## SERVICE BULLETIN

**DATE:** 7-24-2012 **BULLETIN NO:** 12-010

**TITLE:** MASTER DISCONNECT SWITCH SAFETY FUNCTION REPLACEMENT

**PRODUCT SERIES / MODEL:** TR-10 Tie Exchanger - Drone Tamper - Prime Mover  
Gopher Ballast Under-Cutter - DXC 500 Track Renewal Train

FIGURE 1  
 LOCK-OUT LEVER KIT

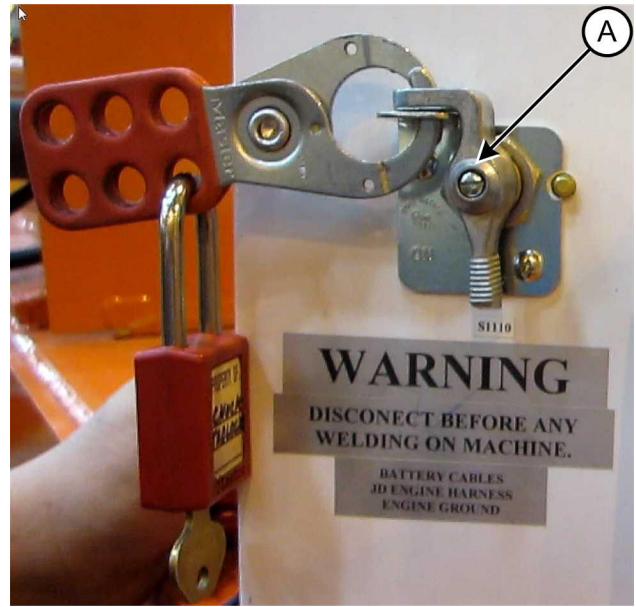
**SUMMARY:** A potential problem has been discovered with the master power disconnect switch (#F025527, #0-3180004-0-04 or #253186-1) when used with the lock-out lever kit (#H5138Y01 or #2010800) to render a machine inoperable. Under certain conditions, when a machine lock-out device is locked and engaged with the switch and lock-out lever, it is possible to manually rotate the master power disconnect switch handle a few degrees, and with some switches, closing the electrical contacts. When forcibly held in position, the electrical power to the machine circuits will remain energized. This action overrides the power lock-out intention and could result in unintentional start-up of the machine.

2. Check if the master disconnect switch (1) is equipped with the lock-out lever kit (A) (#H5138Y01 or #2010800) as shown in Figure 1.
  - a. If the machine is NOT equipped with the lock-out lever kit, the master disconnect switch does NOT have to be replaced.

**OPERATIONAL IMPACT:** Harsco Rail strongly recommends replacement of the current master disconnect switch with a new and different master disconnect switch (#5018833) designed to eliminate the possibility of the switch contacts closing as discovered when it is locked-out with a device designed to prevent energizing the circuits. The replacement switch mounts and connects just like the old switch.

FIGURE 2  
 MASTER DISCONNECT SWITCH CONTACT STUDS

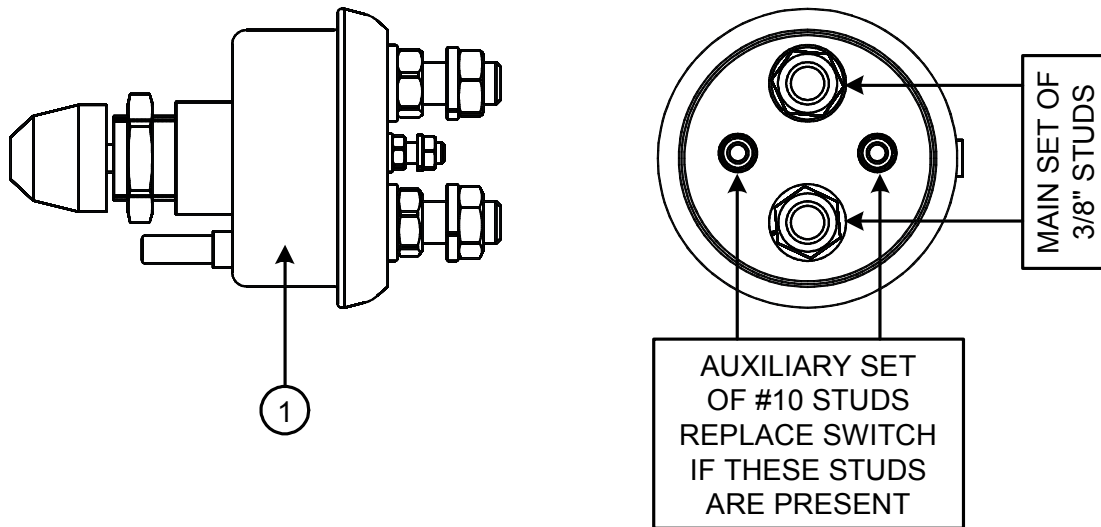
- b. If the machine is equipped with the lock-out lever kit, proceed to Step 3.
3. Inspect the contact studs on the rear of the master disconnect switch (1).

- a. If the switch has only one set (two) of 3/8" studs, the switch does NOT have to be replaced.
  - b. If the switch has one set (two) of 3/8" studs and an auxiliary set (two) of #10 studs, the switch SHOULD BE REPLACED by the new master disconnect switch #5018833. See Ordering Master Disconnect Switch.

- c. If the auxiliary set of #10 studs are currently being used on the existing switch, BE SURE to make the Service Department aware of this when ordering the new switch to find out on where to re-connect the wires.

**FIGURE 3  
NEW MASTER DISCONNECT SWITCH INSTALLATION**

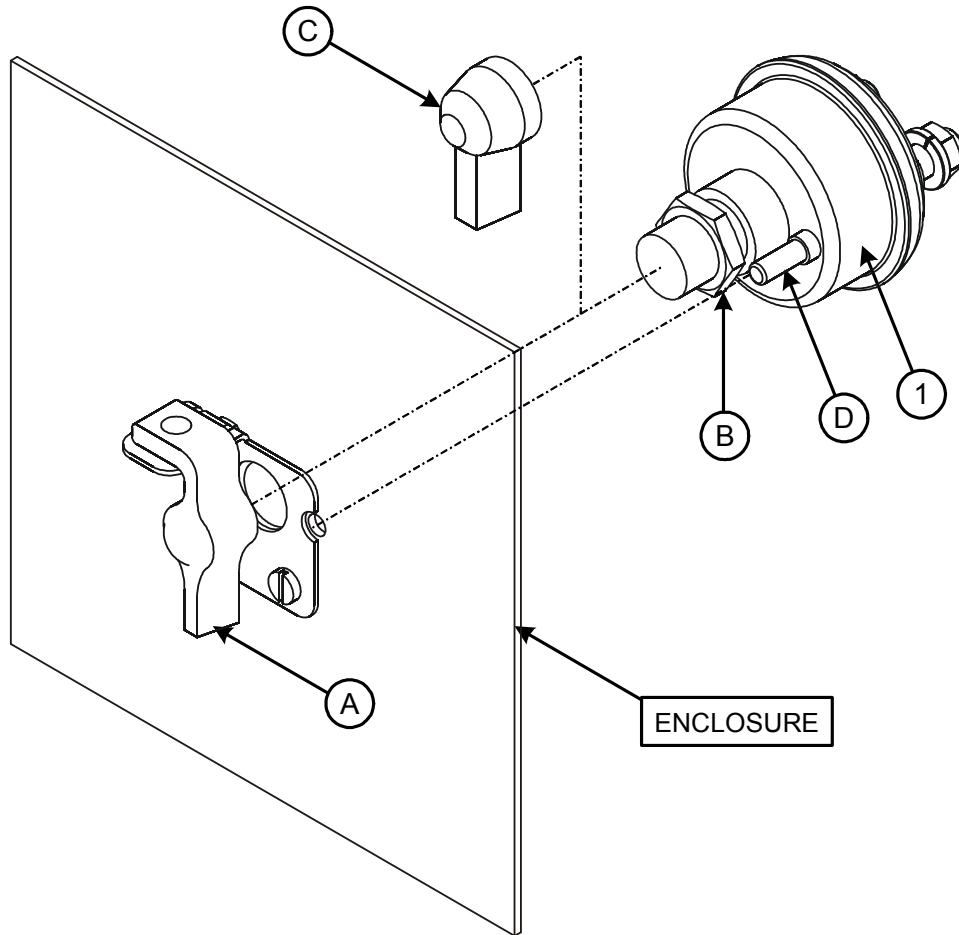
1. Disconnect the cable from the battery negative (-) terminal that runs to the machine ground. Then disconnect the cable from the battery positive (+) terminal that runs to the existing switch (1).

2. Remove the cables from the existing switch (1) and label for proper re-assembly.
3. Remove the lockable rotation knob (A) from the existing switch (1). Save the lockable rotation knob (A), it will be re-used with the new switch (1).

4. Loosen the jam nut (B) and remove the existing switch (1) from the enclosure. Discard the existing switch (1), it will not be re-used.
5. Remove the supplied rotation knob (C) on the new switch (1). Discard the supplied rotation knob (C), it will not be used.

6. Install the new switch (1) in the mounting hole of the enclosure and apply the jam nut (B), verifying that the anti-rotation pin (D) on the new switch (1) is properly positioned in its mounting hole. Then tighten the jam nut (B) securely.

7. Install the existing lockable rotation knob (A) that was removed in Step 3 to the new switch (1).
8. Re-connect the cables that were removed in Step 2 to the new switch (1) as they were connected on the old switch. Then tighten all connections securely.

- a. If the old switch had wires connected to the auxiliary set of #10 studs, re-connect the wires per the instructions from the Service Department.
9. Connect the cable from the new switch (1) to the battery positive (+) terminal. Then connect the cable from the machine ground to the battery negative (-) terminal.

10. BE SURE all personnel are clear of the machine. Turn on the new switch and check for proper function.
